Attachment 1:	Boffa Miskell 15 March 2019: Canterbury Coal Mine RFI Response: Ecological Impact Assessment Report
Attachment 2:	Boffa Miskell 23 November 2017: Canterbury Coal Mine Tara Stream Sediment Retention Pond Ecological Assessment
Attachment 3:	Boffa Miskell 12 January 2017: Canterbury Coal Mine Ecological Significance Assessment of Tara Stream Wetland, the Northern Elf and Bush Gully Stream
Attachment 4:	JH Rekker Consulting Limited 16 December 2019: Response on Hydrological Matters
Attachment 5:	CCR Discharge to Land Resource Consent Application
Attachment 6:	Tips Dams and Voids Principal Hazard Management Plan (PHMP)
Attachment 7:	Ground or Strata Instability PHMP
Attachment 8:	CCO2tele Water Quality Monitoring Results

#	Further Information Request	Response
1	Please provide a map identifying all individual seepages/wetlands located inside the MOA (Mine Operating Areas) and within the zone of influence. This map should include the seep/wetland boundary and identify the location of seeps/wetlands that may have already been removed from any location within the MOA.	<p>An assessment of the effects of mine operations on the ecological values has been prepared by Boffa Miskel

Figure 2 Cross section A-A' showing current topography and location of seepage wetlands and 'raised spring'. Ground water system supplying these seepage wetlands is not expected to be affected.

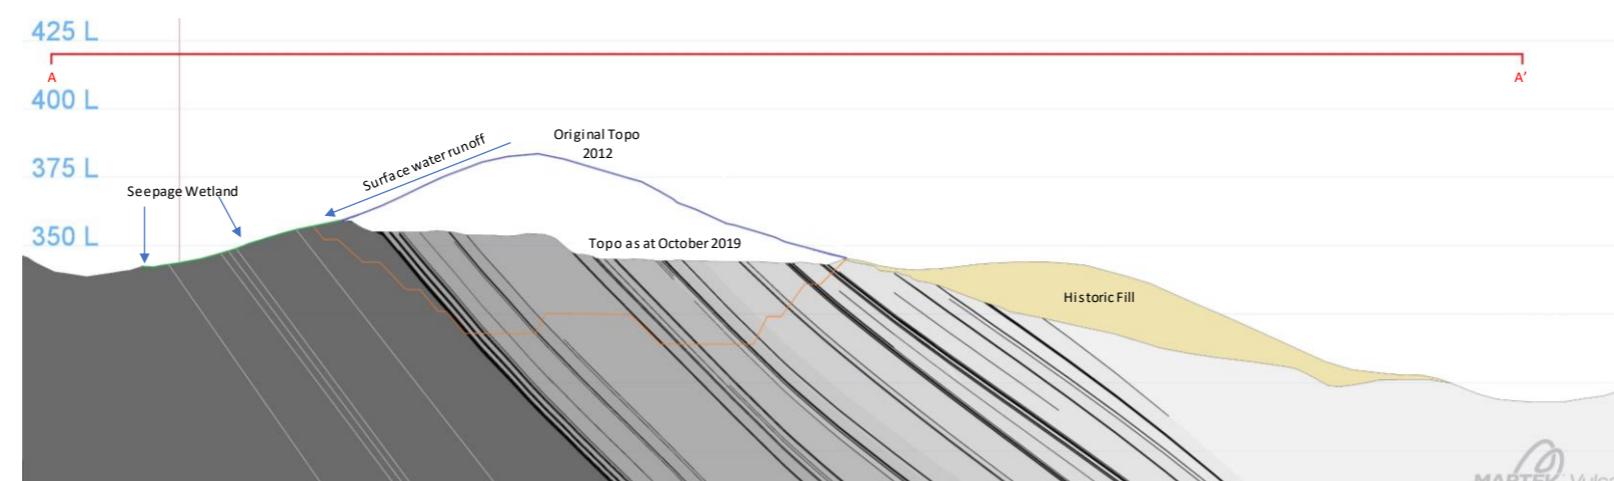
2 Using the map and information in response to question 10, an assessment of the potential ecological effects on seeps/wetlands and a description of any measures to avoid, remedy, mitigate or offset adverse effects.

Outside of the MOA, gullies amongst the farmland on the north-west side of the mine support seepage wetland vegetation in places, and are predominately comprised of a mosaic of wīwī rushland, *Carex geminata*-Sinclair's sedge sedgeland and introduced grassland (Boffa Miskell Report, January 2017, Appendix 3). Within one of these gullies is a distinctive raised spring, with a spongy substrate and a low stature turf, dominated by the introduced jointed rush and moss, which supports a higher diversity of indigenous wetland plant species. These seepages and wetlands are of moderate ecological value. As a result of ecological field studies, the MOA was reduced in size to avoid the inclusion of many of these seepage wetland areas, including the aforementioned distinctive raised spring. **Figure 1** presents the final MOA in respect of the seepage wetland described above. **Figure 1** also presents the location of the cross sections presented in **Figures 2** and **3** which are explained further herein.

Figure 2 below, presents a cross section of the proposed workings in relation to the seepage wetland and original landform (prior to mining). The pit shells will avoid direct impacts (i.e. vegetation removal) to these communities. However, there is the potential for temporarily reducing the area of surface water runoff that may potentially report to the wetland caused by the excavation of overburden and coal within the pit shells. This will only occur for a short time frame while the pits are developed, noting that the wetland is fundamentally groundwater dependent. Following backfilling and recontouring/rehabilitation of the final landform, the surface water reporting to the seepage wetland will be reinstated as presented in **Figure 3**.

Figure 4 Additional Land Parcels to authorise the discharge of coal ash, lime and mussel shells to land within the MOA

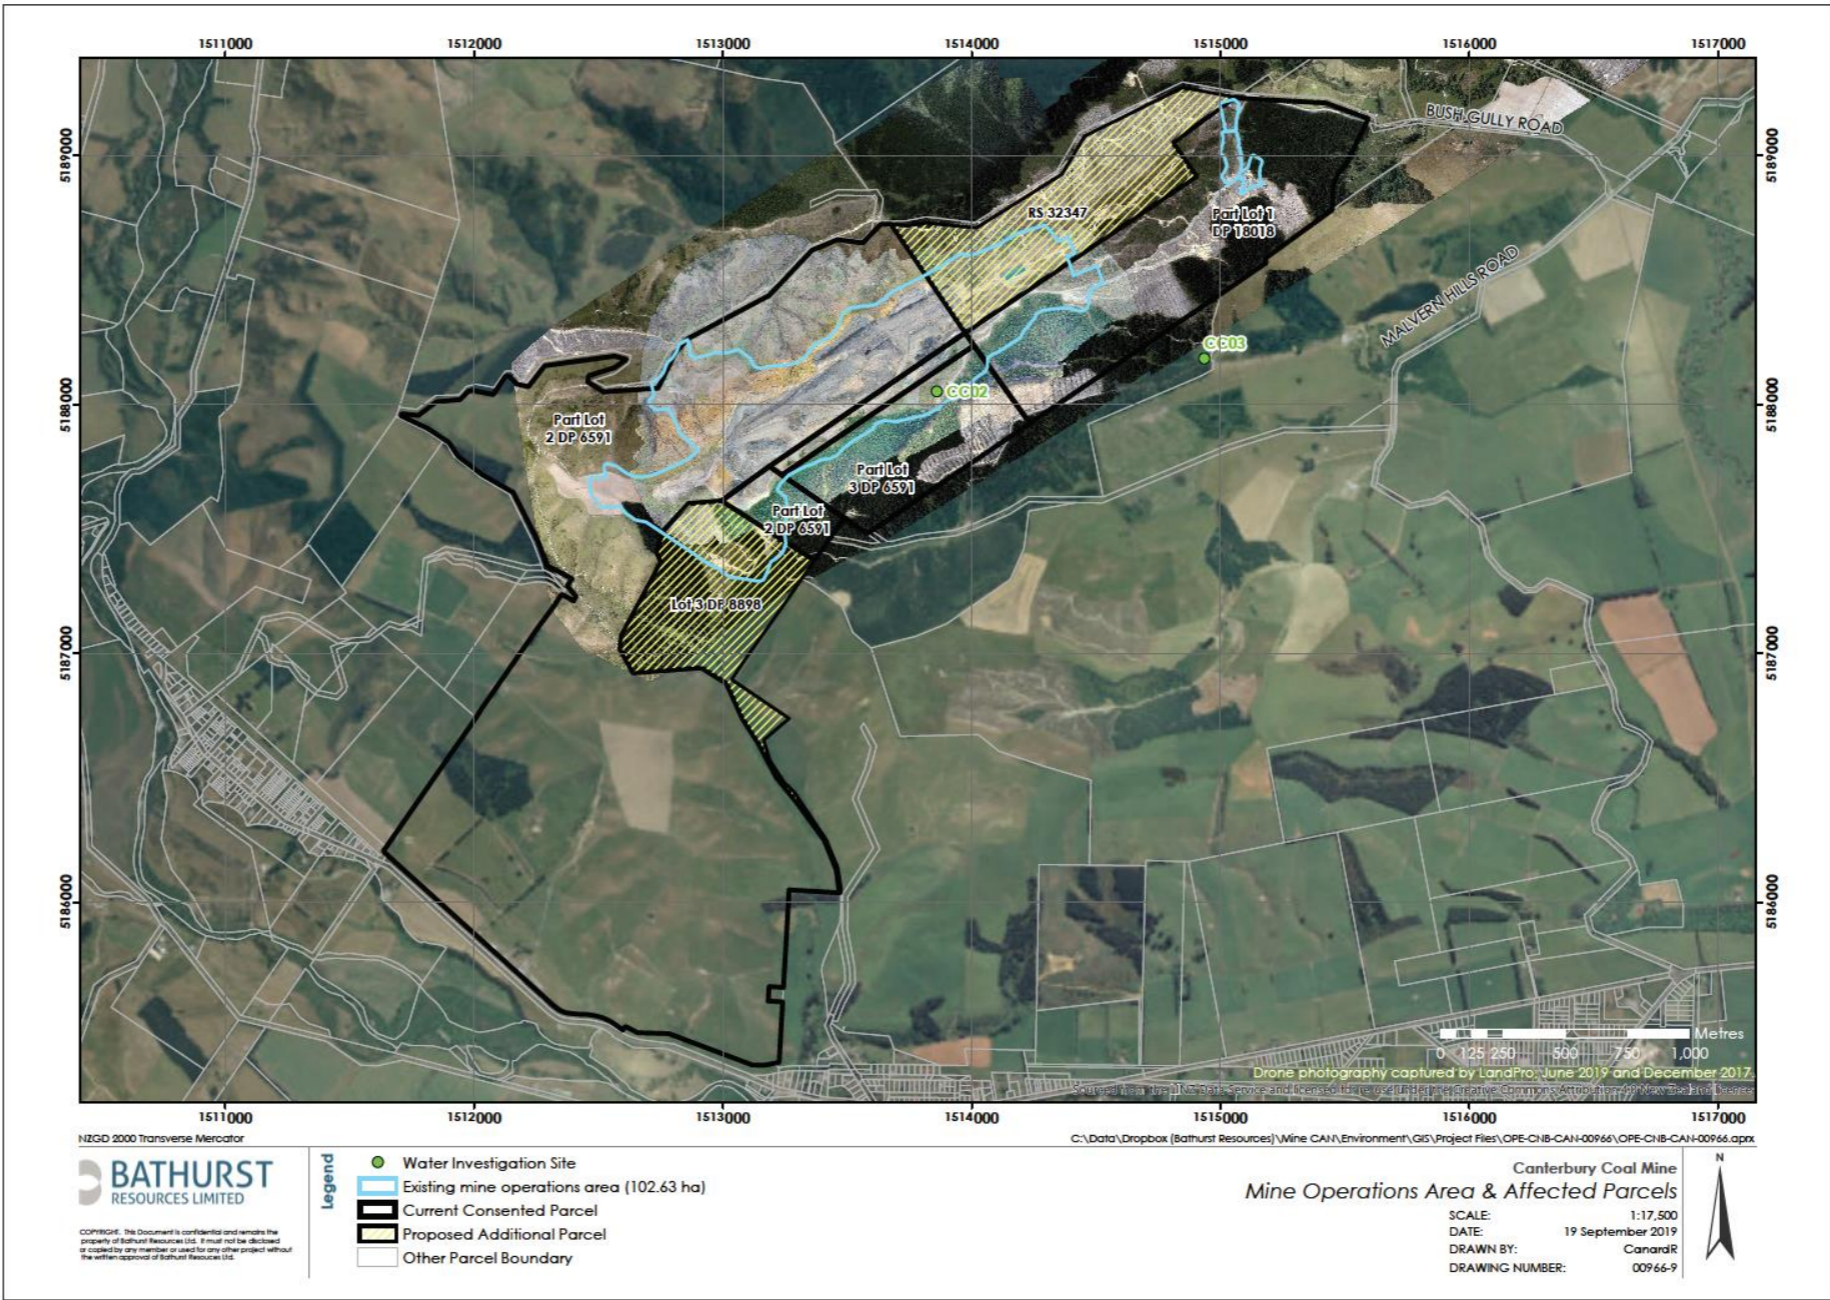
3	Confirmation whether CCR disposal has occurred beyond the area identified on Figure 2 and if it will be part of the wider site rehabilitation.	<p>CCR has been disposed of outside of the areas marked on Figure 2 as shown within the RFI dated 18th October 2019. We do not agree with ECan’s analysis of the consented baseline and we have discussed this further in our covering letter and its attachment. In summary however our view is that CCR (and lime products and mussel shells) can be disposed of in the area shown attached to CRC 170540.</p> <p>It is acknowledged that the MOA extends into two additional land parcels which are not shown on the plan attached to CRC170540. These additional land parcels are shown in Figure 4 below. As such it is considered appropriate to include an additional consent application to discharge contaminants to land. This is attached as Attachment 5. It is noted that this application cross references to material that is contained within the applications that are currently before ECan and should be read in conjunction with these (refer CRC201368).</p>

Figure 6 Representation of Single Bench Batter slopes and Multi-bench slope (diagrammatic only)

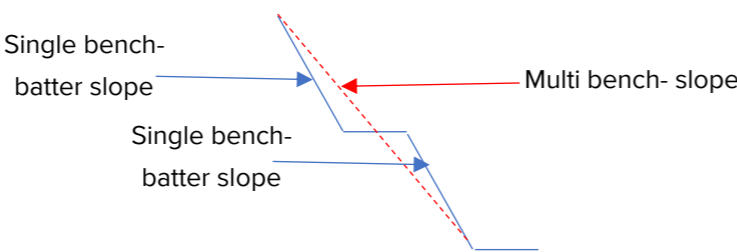
7	Please provide a single maximum slope angle of the draft mine closure criteria and final mine closure criteria specify different maximum slope. The geotechnical report also cites different stable slope angles for ELF fills.	<p>RFI question 7 relates to two different slope angle "types". The first part of the question relates to the slope angle associated with mine closure and the second part of the question relates to pit excavation angles. Both slope angle "types" are addressed herein.</p> <p>The earthworks application incorrectly stated that 21° slope was equivalent to a 1 in 5. This is in fact a 11.3° slope and is a general requirement of the access arrangement with landowners where allowance is also made to return a landform back to the landowner that resembles the original landscape as closely as practicable, particularly in areas with naturally steeper slopes prior to mining. Final landform design criteria set a maximum slope angle for engineered landforms constructed as backfill into completed mine pits to ensure global stability goals are met. This design criteria takes precedent over any original (pre-mining) slope angle. Final landform designs are reviewed against original topography to ensure access arrangement mine closure criteria are met. For clarity, Figure 5 provides an excerpt from the global earthworks consent application.</p> <p>3.3.2 Mine Closure Criteria</p> <p>It is an objective of the design concepts for the final landform of CCM that mine closure criteria are met, and includes a number of matters related to slope, and the relinquishment of land.</p> <p>Land shall not exceed a 21-degree slope (equivalent to 1 in 5) unless the original contour of the relevant part of the land was steeper. All topsoil shall be spread as evenly as possible, and compacted as far as practical. The soil fertility shall be no less than the soil fertility prior to Mining and/or Mining Operations and a cover crop suitable for growing rehabilitated trees or pasture similar to the species of those removed by BCL should be sown or established, including the control of gorse and noxious weeds. All fences, including earthworks and other improvements shall be reinstated to the same condition as they were in prior to Commencement or as agreed with relevant land owners.</p> <p>The relinquishment of land back to the landowner should be done so in a timely manner when the rehabilitation objectives have been achieved and agreed to as per relevant access arrangement agreements.</p>

The Geotechnical report provides ELF and Stockpile Design Parameters as set out in section 6.4. of that report. The Design Parameters provides two slope angles, one for single bench batter slopes of maximum 10m in height of 27° (represented by the blue solid line in **Figure 6**), the other provides a limit to a continuous slope or multi-bench slope of 21° (shown by the red dashed line in **Figure 6**). **Figure 6** has been prepared only to provide diagrammatic representation of the two different slope types. **Figure 7** presents an excerpt from the global earthworks consent application which sets out the single bench and multi-bench design angles.
